MFN 08-076

Docket No. 52-010

Subject: **Response to Portion of NRC Request for Additional Information Letter No. 117 Related to ESBWR Design Certification Application - Site Characteristics - RAI Numbers 2.3-4 S03 and 2.3-12**

**Response to Portion of NRC Request for  
Additional Information Letter No. 117  
Related to ESBWR Design Certification Application  
Site Characteristics  
RAI Number 2.3-4 S03<sup>1</sup> and 2.3-12**

**Figure 2.3-4(1) Typical Sketch of Roof Drain**

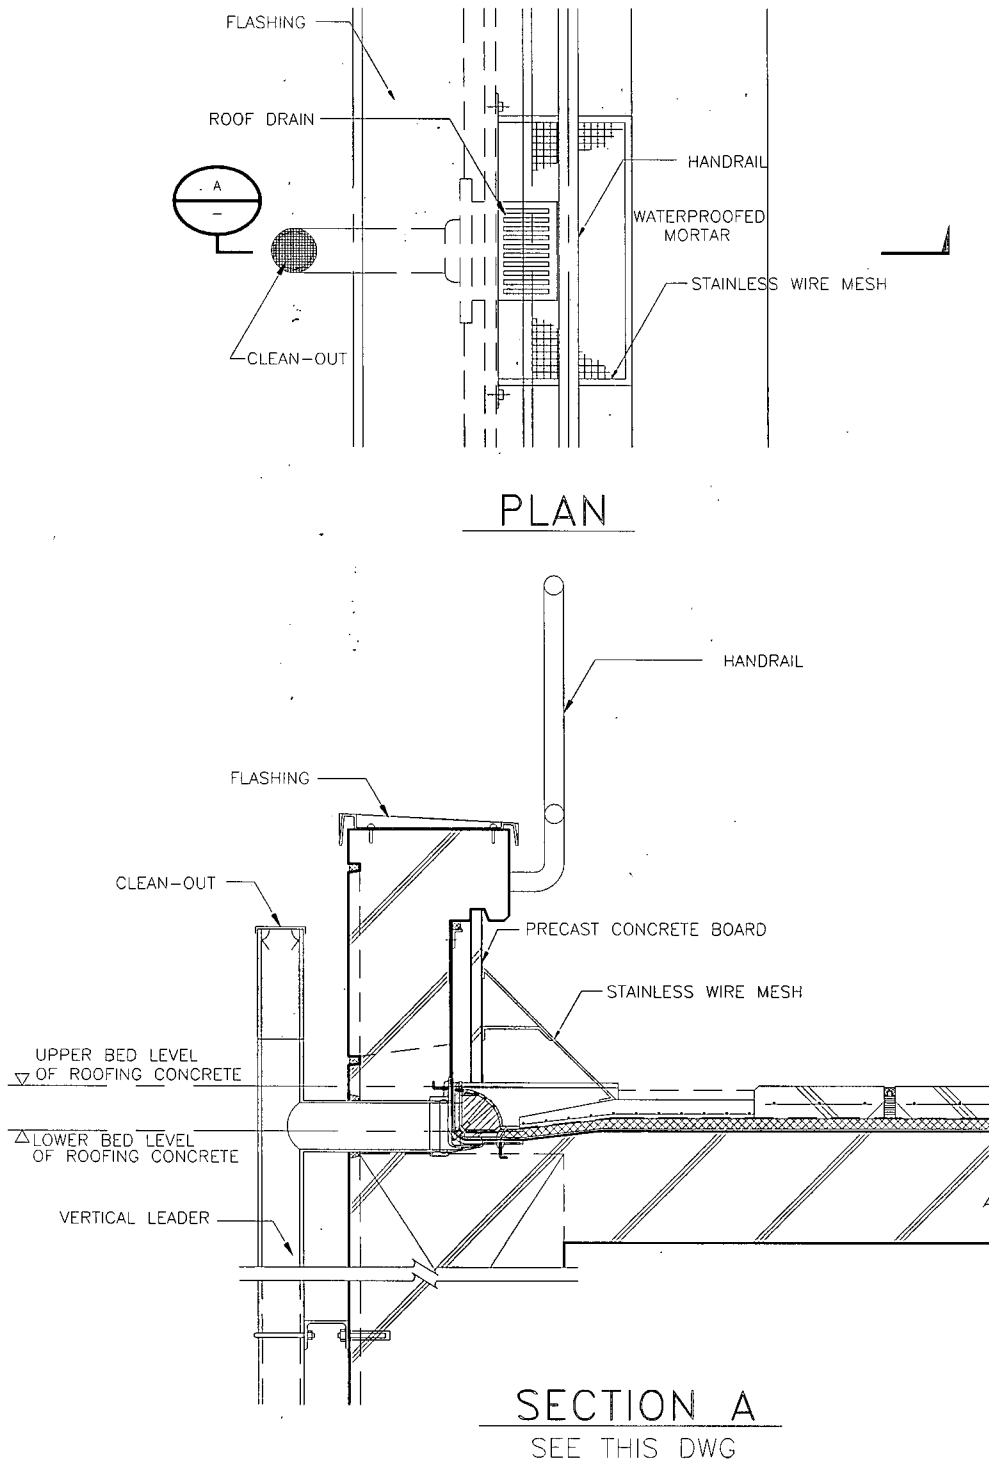
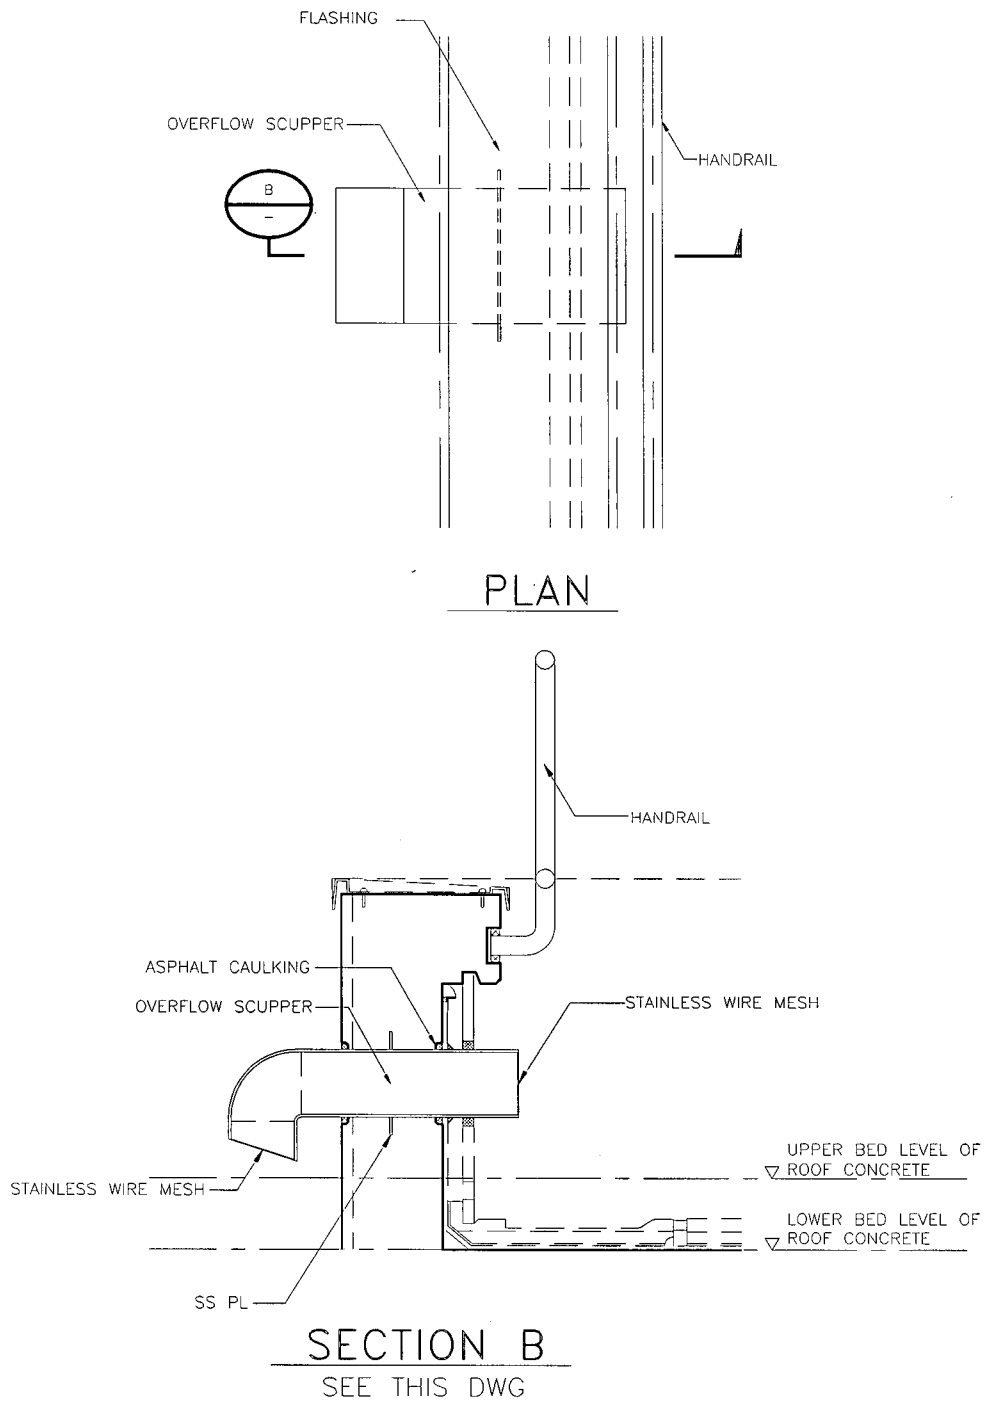
*Footnote 5 to DCD Tier 2 Table 2.0-1 states that the roof scuppers and drains are designed independently to limit water accumulation on the roof to no more than 100 mm (4 in) during PMWP conditions. Please provide details of the design of the roof scuppers and drains demonstrating that an antecedent 100-year recurrence interval ground level snow pack of 2394 Pa (50 lbf/ft<sup>2</sup>) will not clog both the roof scuppers and drains and prevent no more than 100 mm (4 in) of water accumulating on the roof.*

In the ESBWR Standard Plant, roofs are provided with two independent drainage systems. The roof drains form the primary drainage system and the scuppers form the secondary drainage system. As required by the International Plumbing Code (invoked by IBC-2003) and ASCE 7-02, only the blockage of the primary system is postulated when designing the secondary system and for calculating the rain load on the roof.

Figures 2.3-4(1) and (2) show typical sketches of the roof drain and overflow scupper. The design of the roof scuppers and drains follows ASCE 7-02. The elevation of the overflow scupper is set such that the average water depth does not exceed 100 mm (4 in.) in case the roof drains are clogged by snow, ice, or other obstructions.

DCD Tier 2 Table 2.0-1, Note 5 and Table 3G.1-2, Note\*\* will be clarified to state that the depth of water considered on the roof is an average depth.
